SPARC Arena Phase II: JSP23-23

Approval of the request of SPARC Holdings, LLC, for SPARC Arena Phase II: JSP23-23 for a Section 9 waiver. The subject parcel is in Section 35, east of Novi Road and south of Nine Mile Road. It is zoned I-1, Light Industrial. The existing building is a former industrial building and was erected prior to the adoption of the Façade Ordinance. The applicant proposes to raise portions of the façade elevations to expand the recreational activities offered.

SPARC Arena – Phase 2 JSP23-23

SPARC Arena, JSP23-23

LINE
OF SIGHT
ELEVATIONS
SHEET #

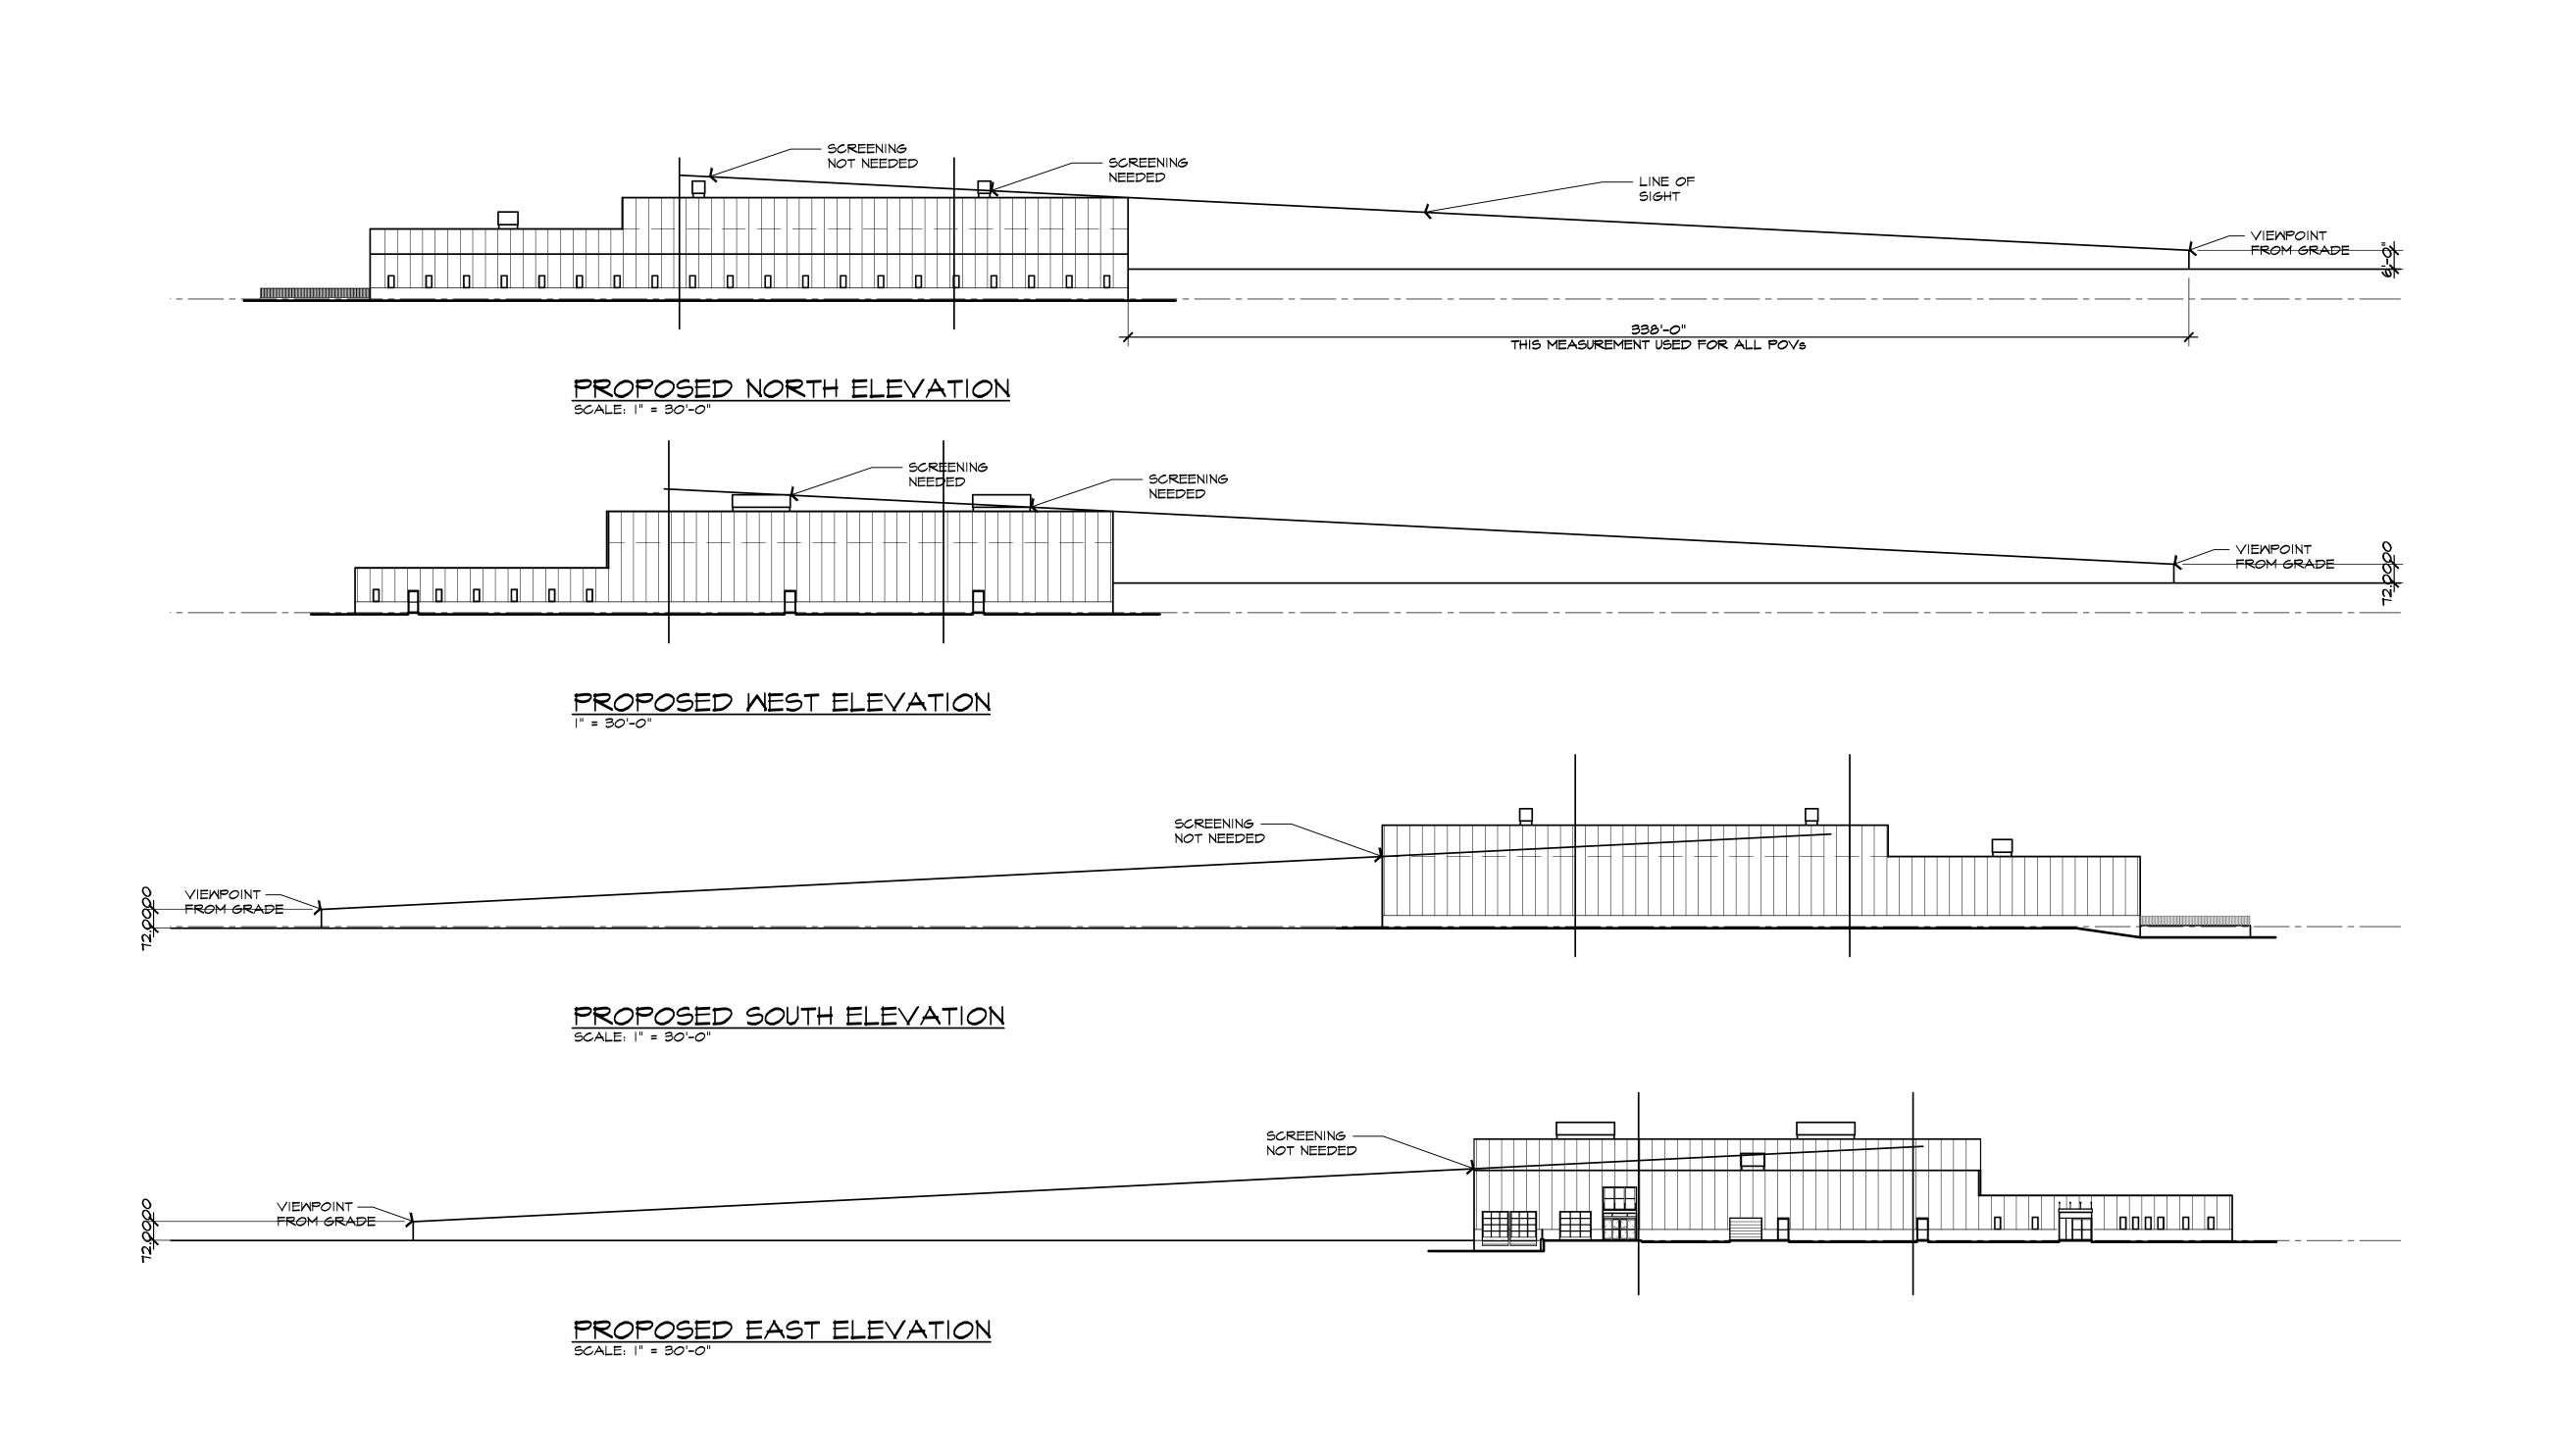
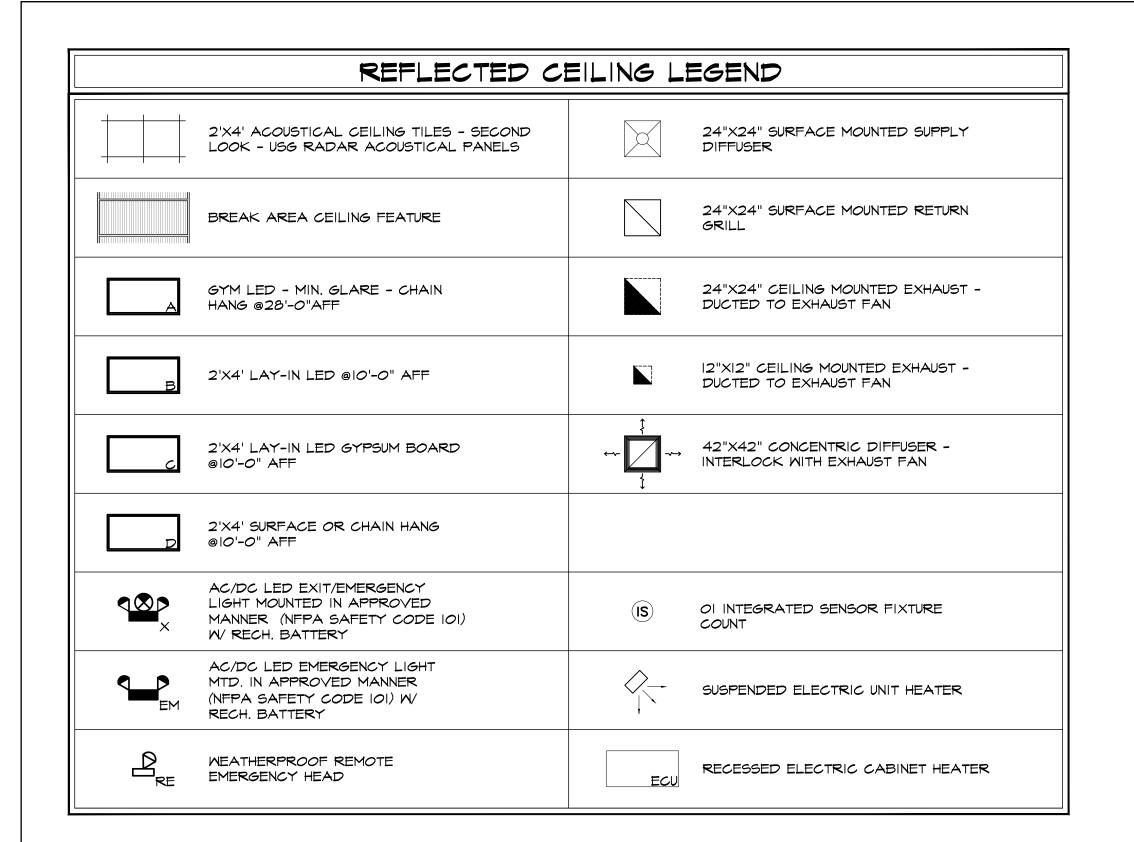
2. <u>RTU Screening</u> - It should be noted that all roof top units must be screened from view from all vantage points both on-site and off-site using materials in compliance with the Façade Ordinance.
